ISSUE: Certificate of Appropriateness for new construction

APPLICANT: City of Alexandria and Washington Metropolitan Area Transit Authority (WMATA)

BAR#2019-00241
2901 Potomac Ave. (2405, 2501, and 3701 Potomac Ave., 3251 Potomac Ave.
[Parcel ID 016.04-01-01], 700 Carpenter Rd, 1702 & 1880 Potomac Greens Dr.)

**Contract No. FQ16146 - Washington Metropolitan Area Transit Authority
(WMATA) Potomac Yards Metrorail Station
LTR-0104-PM-City of Alexandria January 22nd, 2020 BAR Submission**

WMATA POTOMAC YARD METRORAIL STATION ARCHITECTURAL BAR SUBMISSION DOWNSPOUT AND GUTTER DETAILS - PLATFORM				
M NO.	CONTRACT NO.	SCALE:	DRAWING NO.	SHEET NO.
M1316	FQ16146		A-593	OF 143

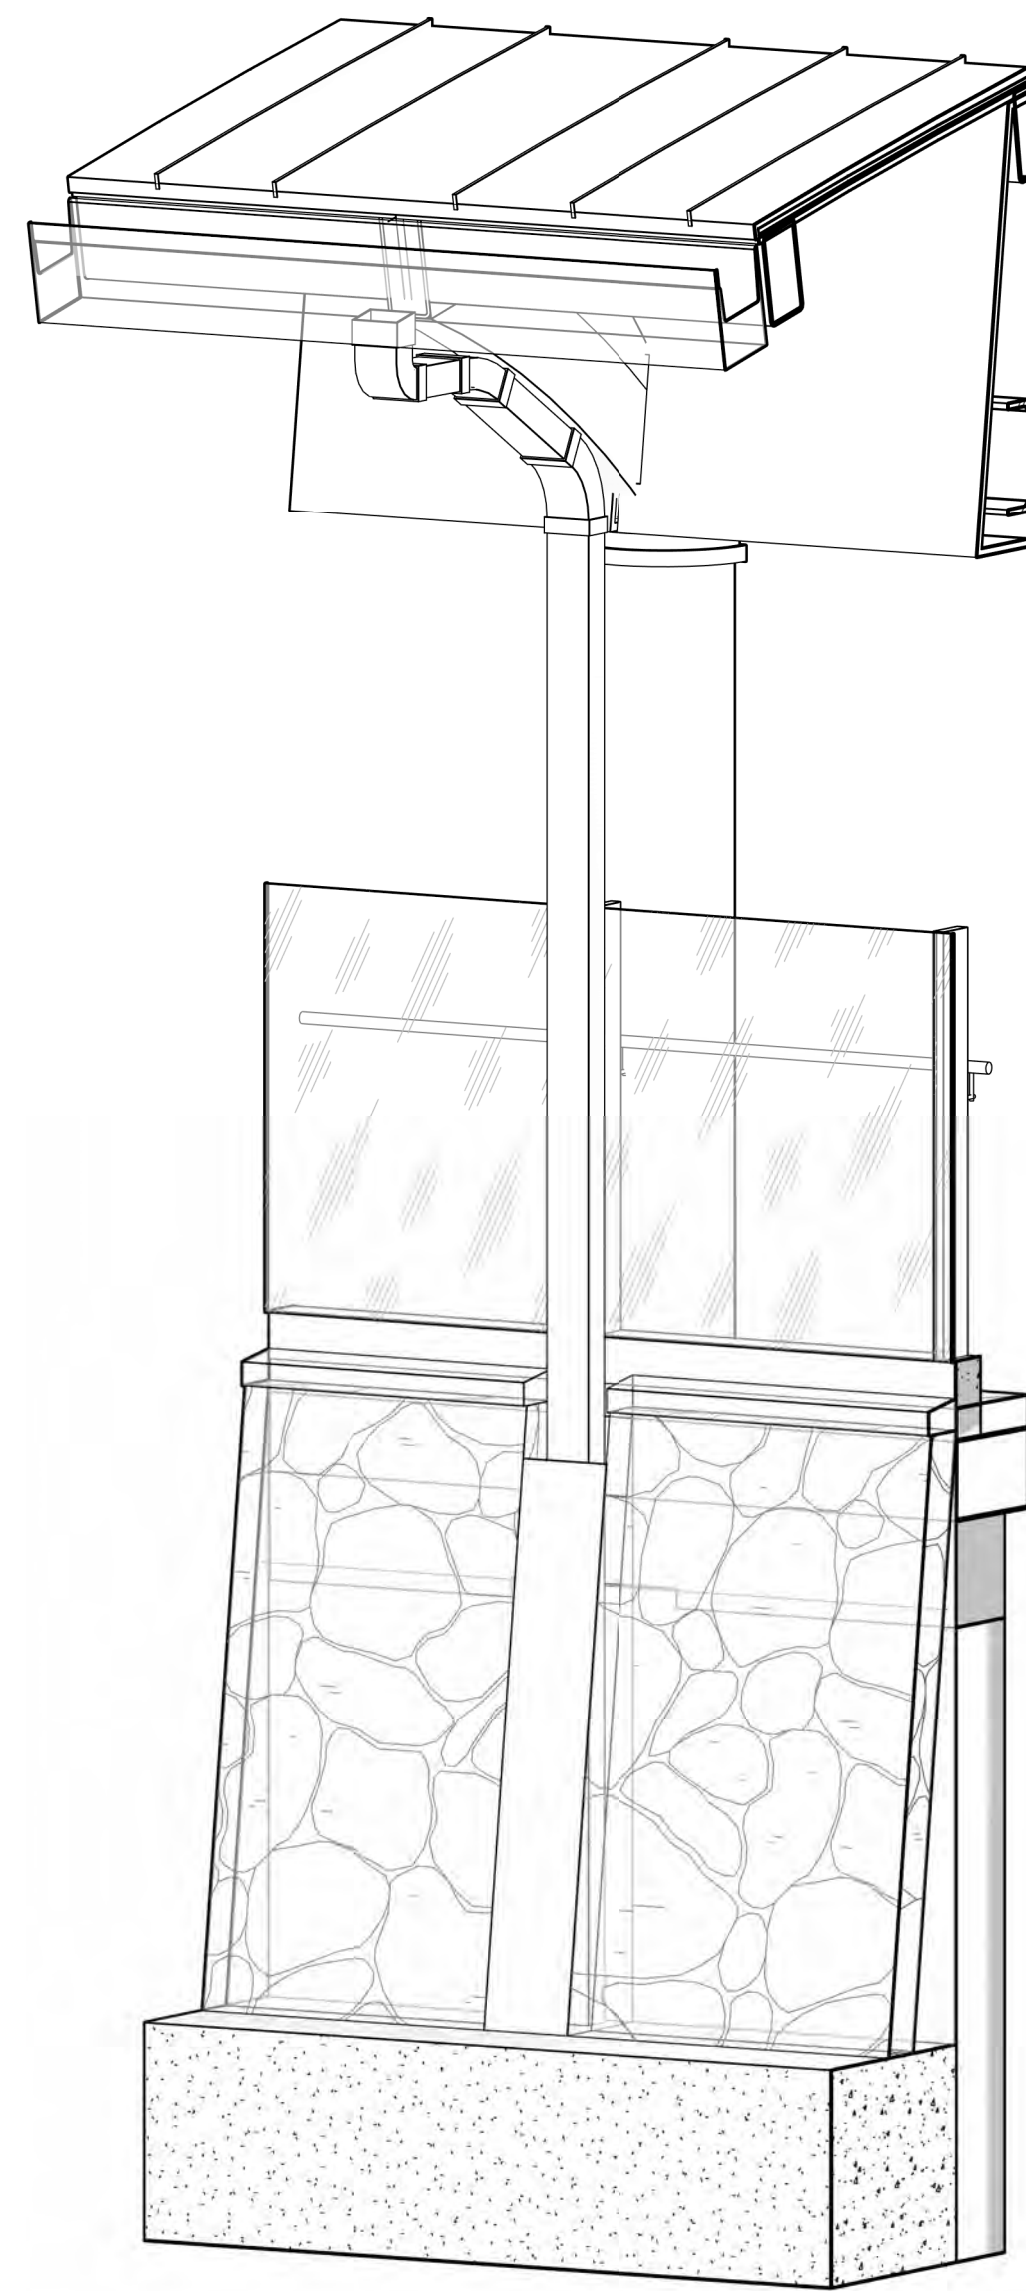
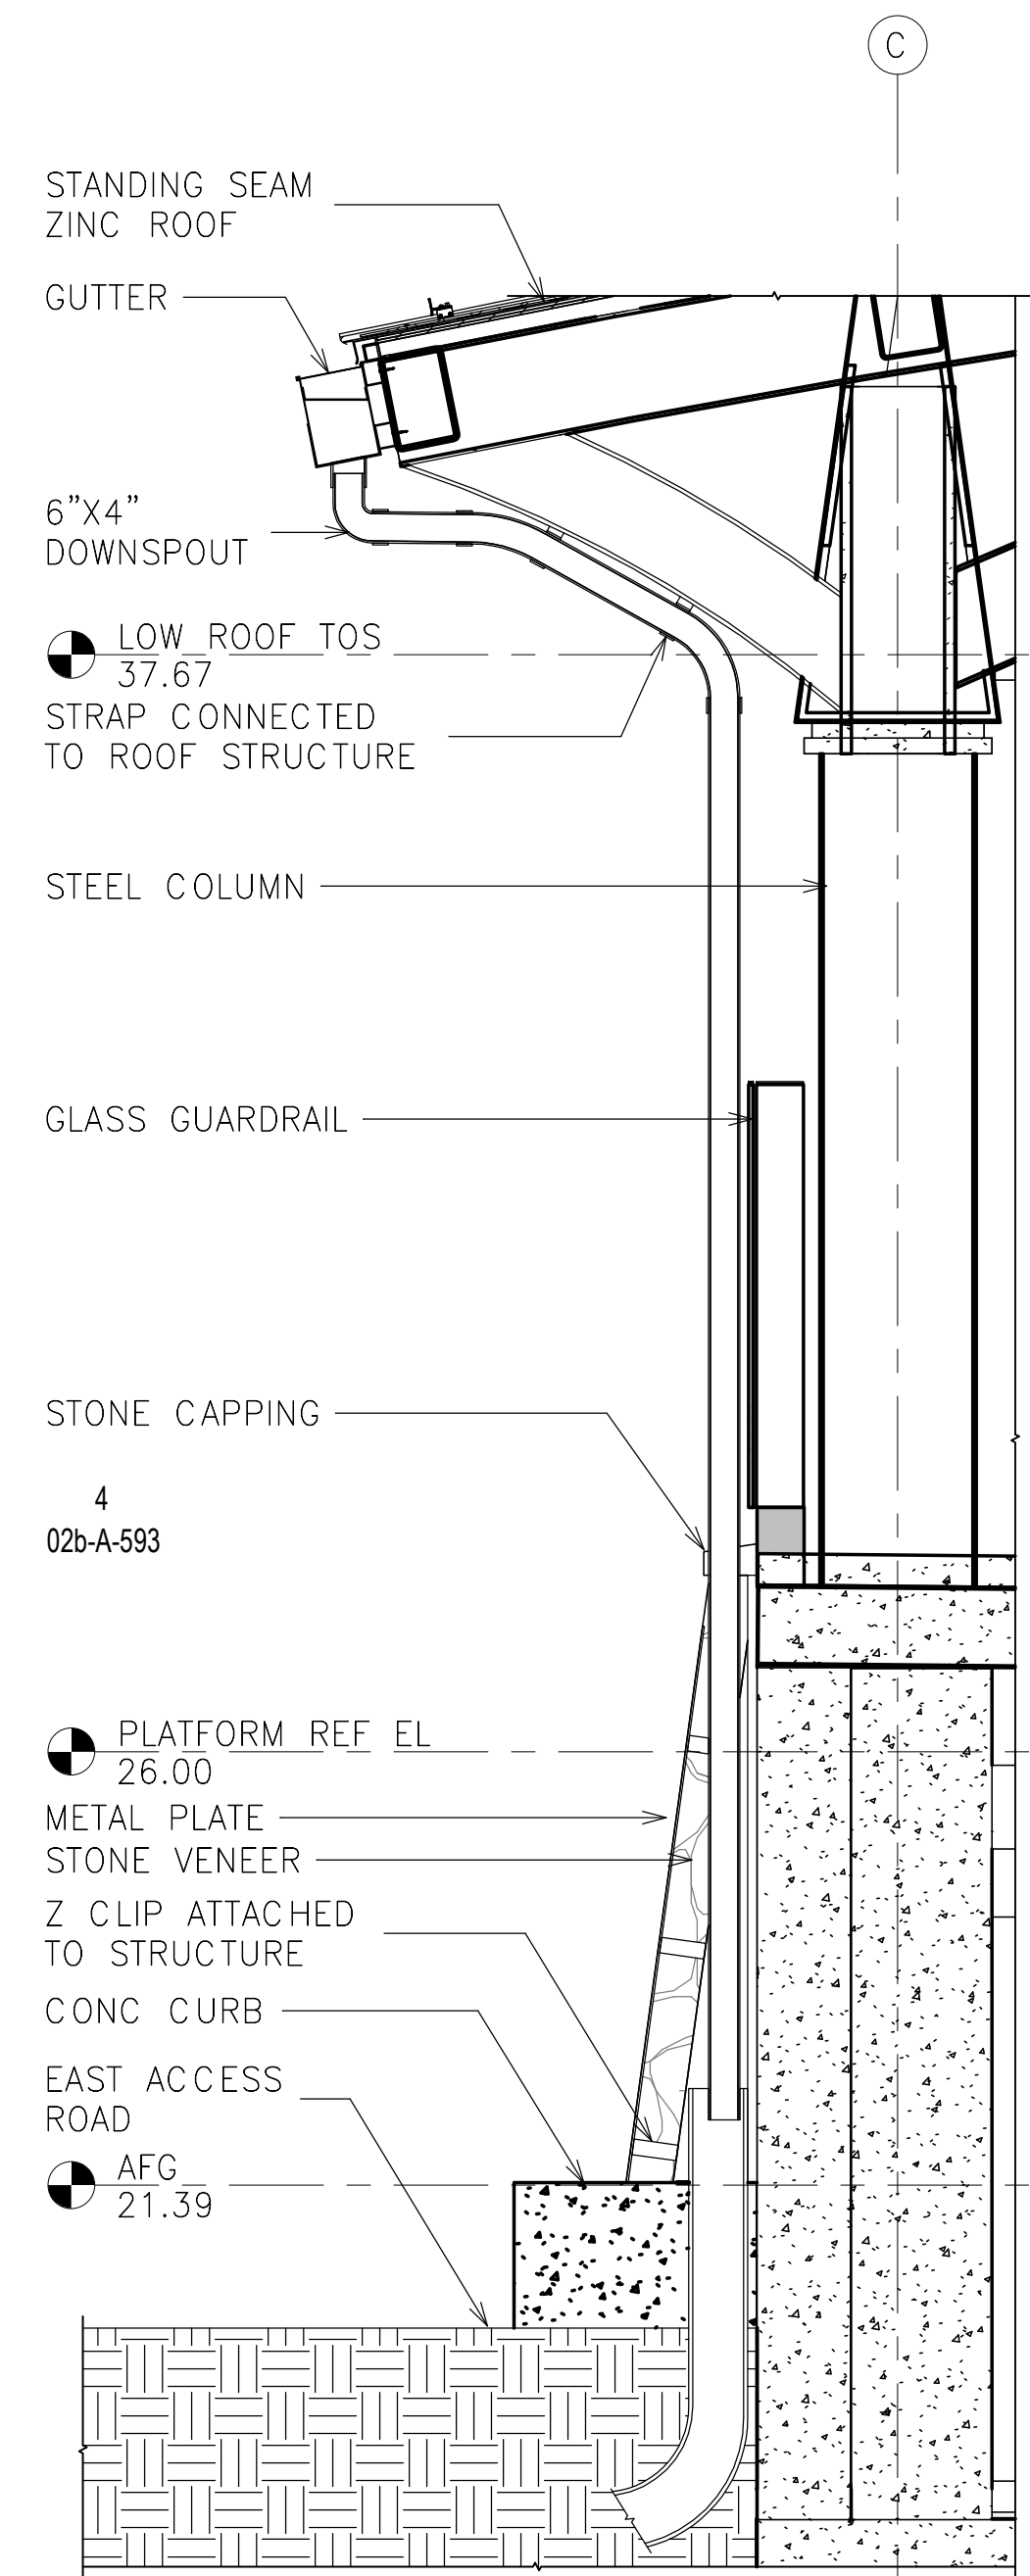
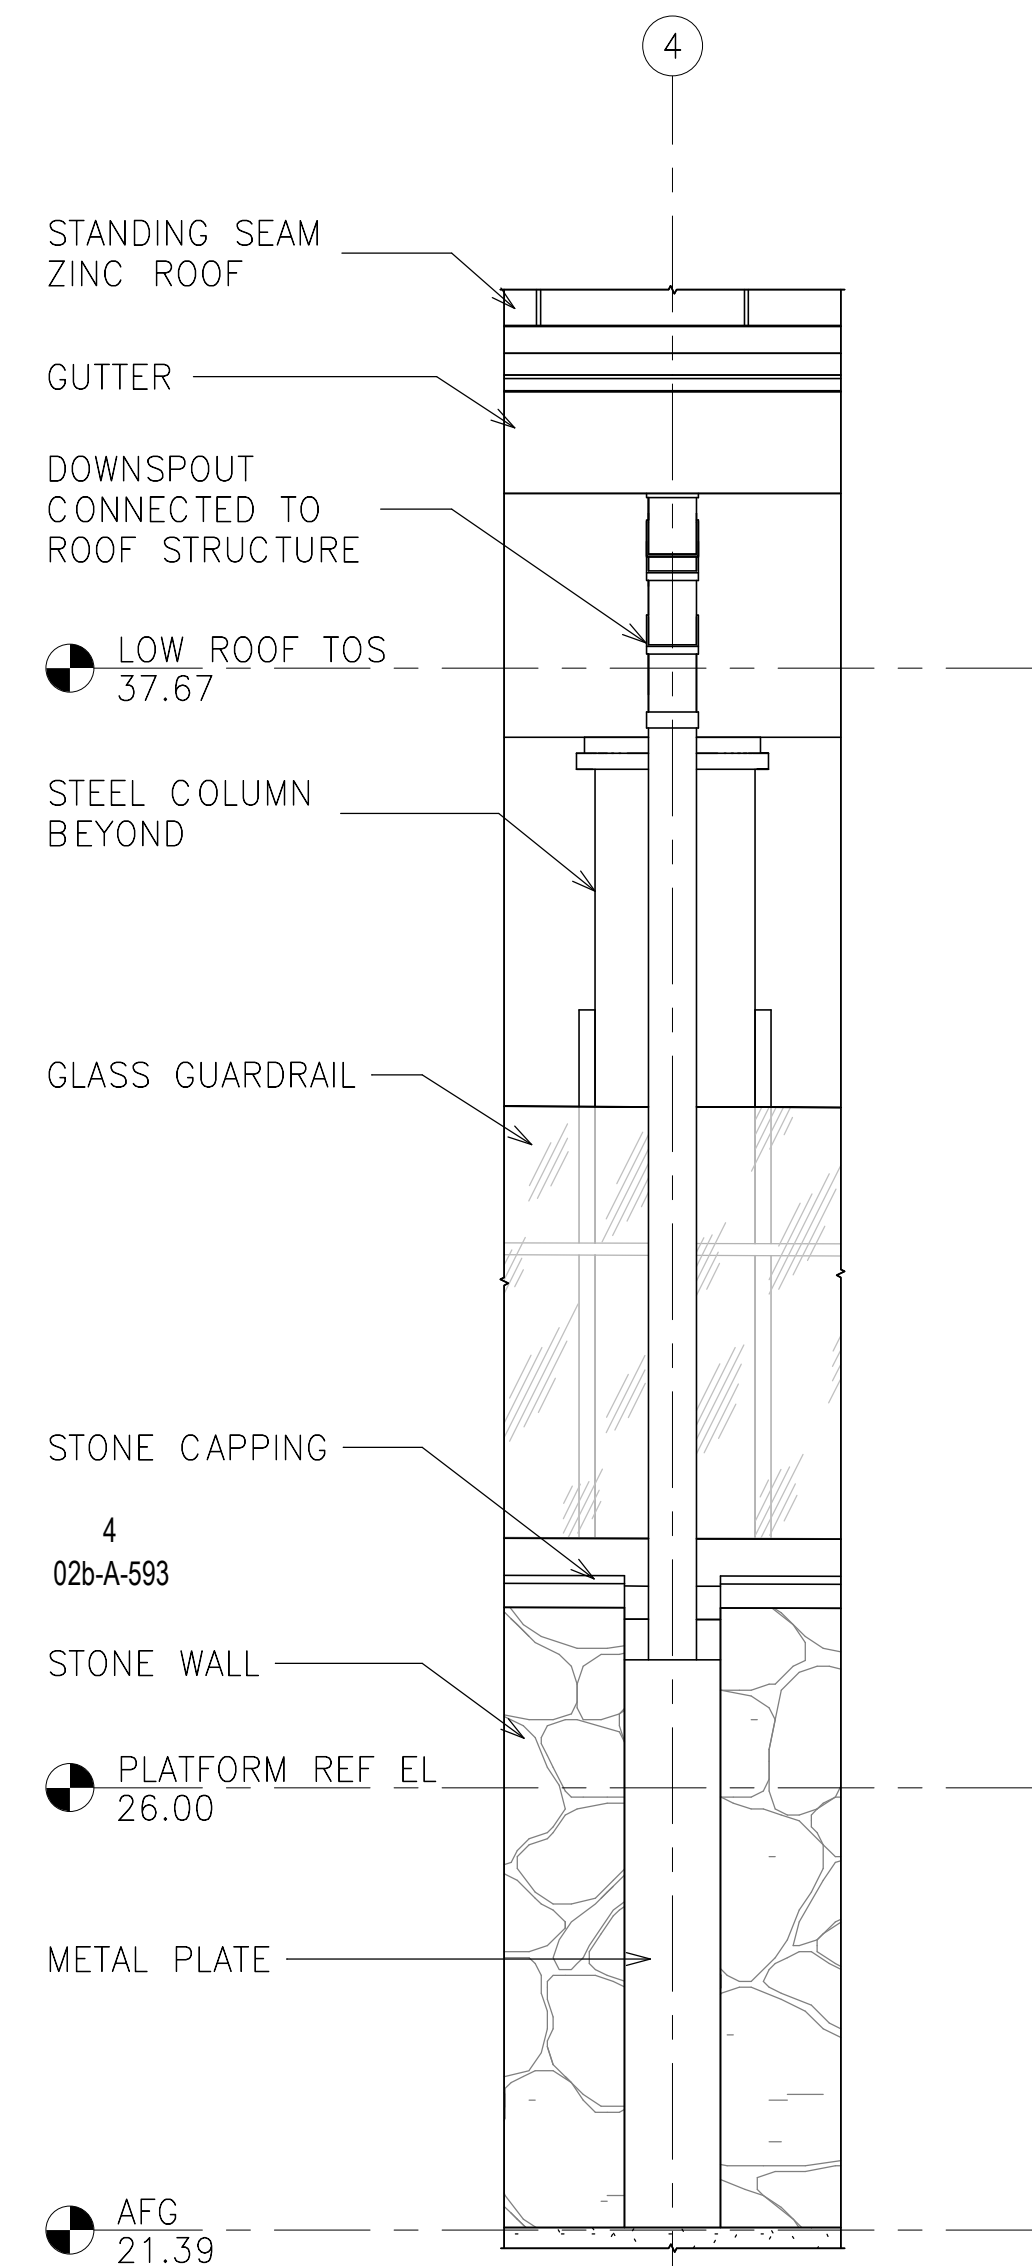
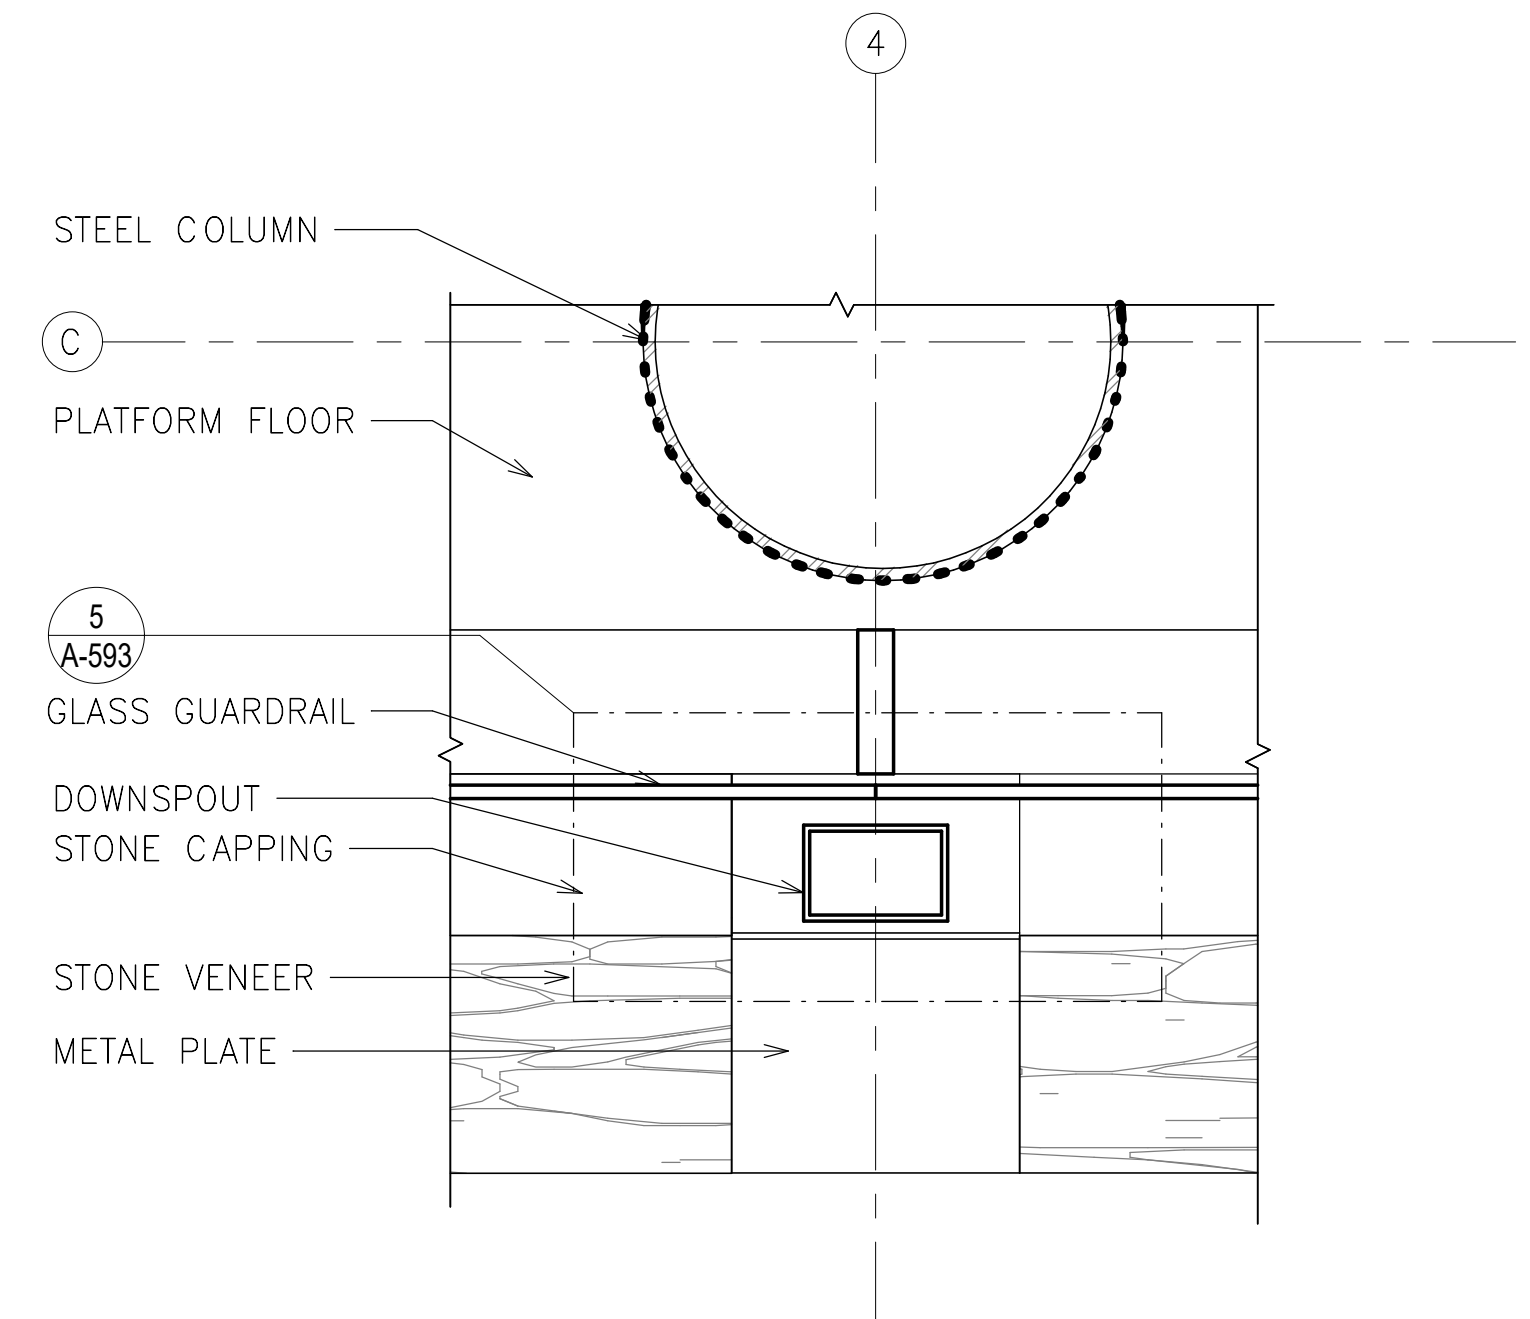
The downspouts, cleanouts and transition to the underground drainage pipe are hidden behind metal cover plates at the battered stone base. These cover plates will have a return on each side that will slip into the stone notch and provide rigidity for the plates. There will be a sloped collar transition at the top of the cover plate that will surround the downspout and rise to the level of the bottom of the coping at the back of the notch.

The final detail that the BAR discussed is the color of the downspouts where they visually conflict with the abutting structural member. This color will have to change when the angled downspout attached to a light grey roof truss member is then attached to a vertical portion of the dark brown color exoskeleton. The downspouts will be prefinished and the color changes will occur at a joint. In general, staff recommends that the downspouts at the platform match the Wickham Gray color of the roof steel structure and the downspouts and cover plates at the stone base match the darker gray Pussy Willow of the steel columns and field stone base. Anywhere the downspout is attached to the Chocolate Brown Met color exoskeleton, should be painted the same brown color. These conditions will be verified by staff in the wall mockup, the construction drawings and in the field.

1. Approval of the downspout details with the color of the downspouts to match the adjacent structural feature and final review of the cover plate details by staff; the Chocolate Brown Met color flat exoskeleton finish; and the guardrail and stone retaining wall, as submitted.
2. Deferral of the cast stone details and west elevation of the entrance pavilion on the west side of the tracks, the glass handrail/guardrail details in the station and exoskeleton connection details.
